ISSUE: Certificate of Appropriateness for alterations

LOCATION: Old and Historic Alexandria District
1328 Michigan Avenue

STAFF RECOMMENDATION

Figure 1. Front Elevation of 1328 Michigan (on the right), looking west.

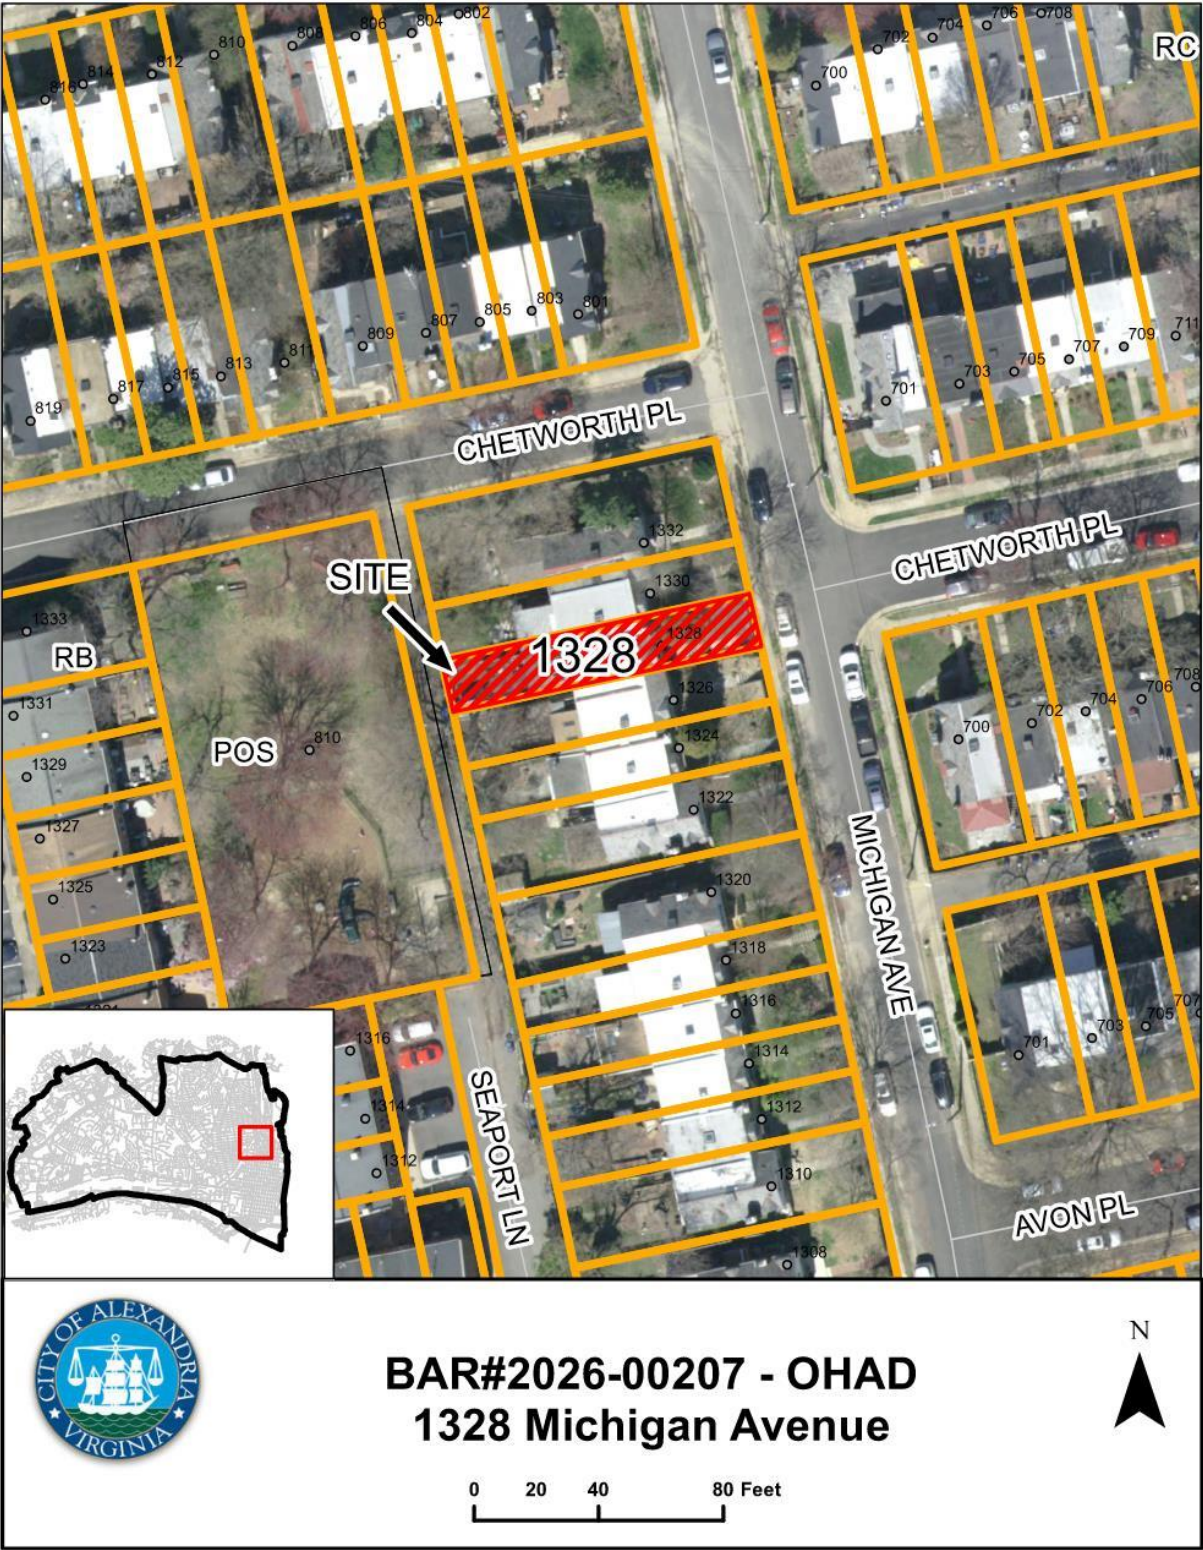
For this Certificate of Appropriateness, staff recommend **denial** of the roof replacement. Staff recommend **approval** for:

Although this is a Later Building, where synthetic roofing materials may be appropriate, the building's architectural elements must also be considered. These townhomes share the same roofing plane. There are no step backs, roofline height changes, or parapet walls between 1326 and 1328 Michigan (see figure 2 on next page). To switch to a different material in the middle of the roofline is not compatible and therefore not appropriate with the overall architecture.
